Reply to Office Actions of February 25, 2005 and June 3, 2005

BRINKS HOFER GILSON & LIONE P.O. BOX 10395 CHICAGO, ILLINOIS 60610 (312) 321-4200 Patent Application for: Table Saw Guard Assembly
Inventor(s): Peot et al.

Attorney Docket No. and Serial No.10710/197 (PTG-1063-PAP)
Annotated sheet 1 of 2

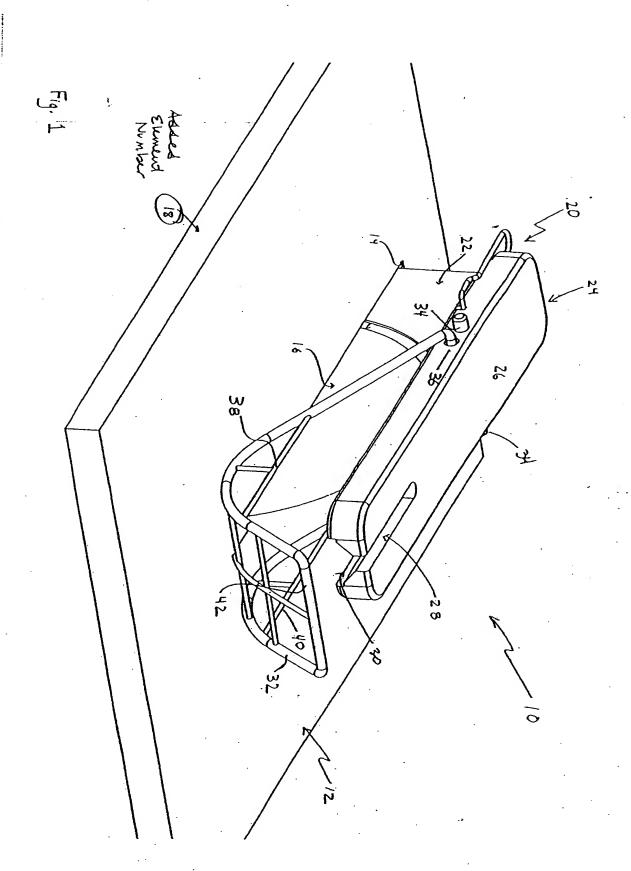
In the Final Office Action dated February 25, 2005, the Examiner objected to the drawings under 37 CFR 1.83(a), stating that the term "frame" as set forth in claims 1 and 17 must be specifically shown in the drawings. The Examiner stated that the replacement sheets filed with the Applicants' Amendment of November 15, 2004 were unacceptable because changes were made that were considered new matter because there was no support in the original disclosure for the specific structure added to the drawings. The Applicants respectfully disagree with the Examiner's contention.

In order to expedite prosecution of the application, replacement sheets 1 and 2 that were included with the Applicants' Amendment of November 15, 2004 have been withdrawn. Applicants submit revised replacement sheets 1 and 2, which modify FIGs. 1 and 4, respectively. The only change on both replacement sheets from the as-filed figures is the addition of element 18, which identifies the frame, through which the saw

blade extends and of which the table top is a part. The structure that element 18 refers to was shown in the as-filed versions of FIGs. 1 and 4. Because claims 1 and 17 each include limitations to a "frame having a table top" and as-filed FIGs. 1 and 4 each included the structure of the frame by showing the table top, and the replacement sheets, which only add the designation of element 18, do not add any new matter to the application. See MPEP § 608.01(I).
